ACCESSION NBR: 8203080247 DOC. DATE: 82/03/04 NOTARIZED: NO DOCKET #  
 FACIL: 50-361 San Onofre Nuclear Station, Unit 2, Southern California 05000361  
 50-362 San Onofre Nuclear Station, Unit 3, Southern California 05000362  
 AUTH. NAME AUTHOR AFFILIATION  
 DIETCH, R. Southern California Edison Co.  
 RECIP. NAME RECIPIENT AFFILIATION  
 EISENHUT, D.G. Division of Licensing

SUBJECT: Forwards Series F potential finding repts processed & classified by GA Co. "F" designation differentiates repts from original 58 issued in interim rept. Addl repts will be submitted as completed.

Subject: Docket 50-361 and 50-362  
San Onofre Nuclear Generating Station  
Units 2 and 3

## SONGS 2&3 SEISMIC DESIGN VERIFICATION

SUBJECT STEEL W/ I W/ TRAY SUPPORTS

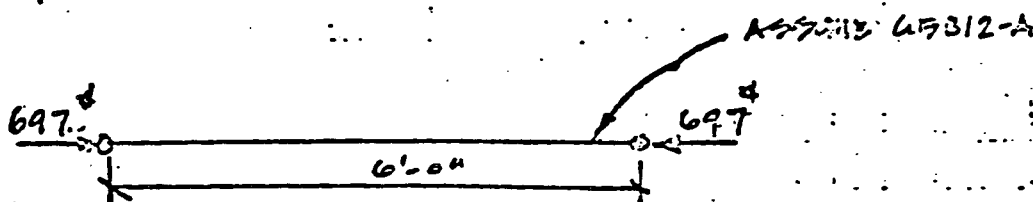
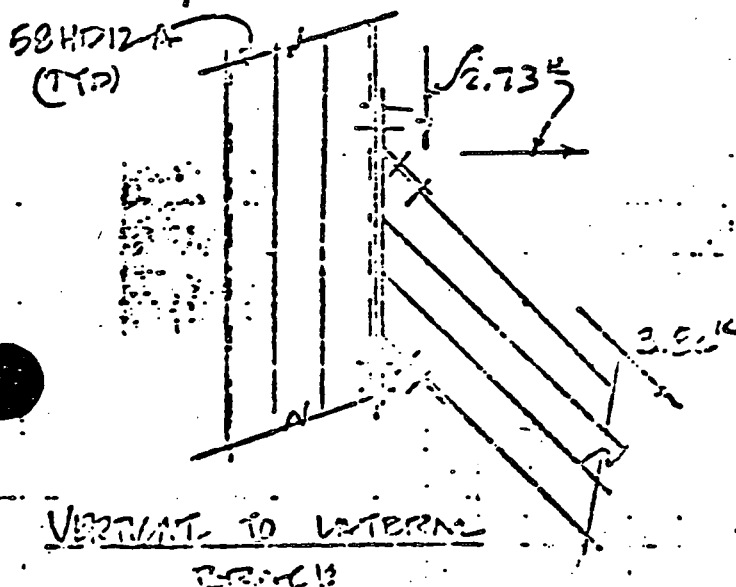
Per Requirement Reference Documents 1 and 2, the Design of Seismic Category I Cable Raceway Support System for SONGS Units 2 and 3 must conform to applicable codes, industry standards and specifications, as outlined in FSAR 3.8.4.2.3 and SONGS Project Design Criteria Manual. It has been found that the calculations on the design of the Raceway Support System make extensive use of design allowables from Globe Strut Catalog (Ref. 3) as the basis for the design. Attachment No. 3 ( 2 pages) shows sample calculation sheets of Bechtel CAL C270-01-03, Sheet 118 and CAL C270-01-02, Sheet 364 using Globe Strut Catalog pullout allowables. Attachment 4 shows the indicated Globe Strut pullout allowable load ratings. For CI-3812 the indicated allowable pullout load is 2474 lb in any 12 inch length. There is no test data, certified test report, or analyses contained in that catalog to indicate the bases for the indicated load, and to demonstrate that the load envelopes all conditions of shear and pullout which can exist in every 12 inch length. Alternatively, there is no indication in the calculation that BPC has such data in their records.
